# Evaluation of Physical Barriers- Hunter Park Station

Address: Hunter Park Metrolink Station, CA 92507

Evaluation Date: 08-03-2021

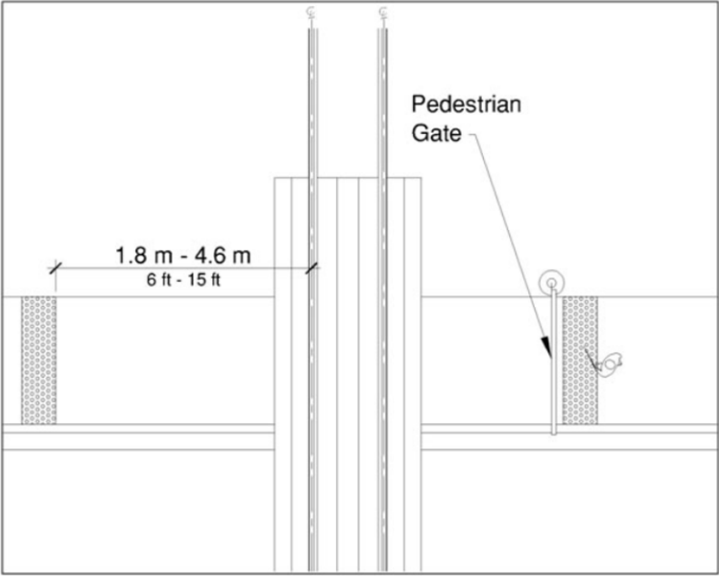
Issues/ Barriers Identified	Recommendations	Comments/ ADA Requirements
<p><b>2. Pedestrian Road crossings</b></p> <p>Pedestrian crossing at 2a, 2b has cracks, level changes more than ¼" high, and gaps in excess of ½" wide and ¼" deep.</p>   	<p>Examine all pedestrian crossings and repair all cracks.</p> <p>Every joint in concrete deeper than ¼" and wider than ½" shall be filled.</p> <p>Every level change along the accessible route greater than ¼" and less than ½" height needs to be beveled (1:2) slope or repaired.</p> <p>Every level change greater than ½" needs to have a ramped surface (1:12) slope.</p>	 <p><b>Figure 302.3</b> Elongated Openings in Floor or Ground Surfaces</p>  <p><b>Figure 303.3</b> Beveled Change in Level</p>  <p><b>Figure 303.2</b> Vertical Change in Level</p>
a) Pedestrian Push Button- Not Applicable	No action by RCTC

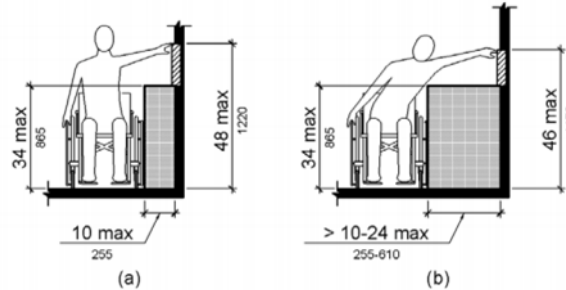
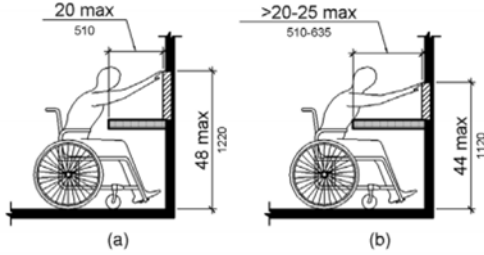
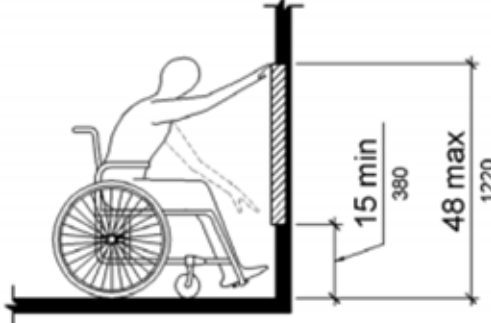
Issues/ Barriers Identified		Recommendations	Comments/ ADA Requirements
ii. Utility covers have gaps/openings wider than 1/2" and deeper than 1/4" 		Close gaps and openings wider than 1/2" and deeper than 1/4", and, remove trip hazards in the accessible route or replace with ADA complaint covers.	Same as item 2 above
<b>4. Platforms</b>			
a. Walking Surfaces			
i. General: Joints and gaps in concrete to be maintained for compliance with 302.3, 303.2, and 303.3.		<p>Examine all pedestrian crossings and repair all cracks.</p> <p>Every joint in concrete deeper than 1/4" and wider than 1/2" shall be filled.</p> <p>Every level change along the accessible route greater than 1/4" and less than 1/2" height needs to be beveled (1:2) slope or repaired.</p> <p>Every level change greater than 1/2" needs to have a ramped surface (1:12) slope.</p>	Same as item 2 above
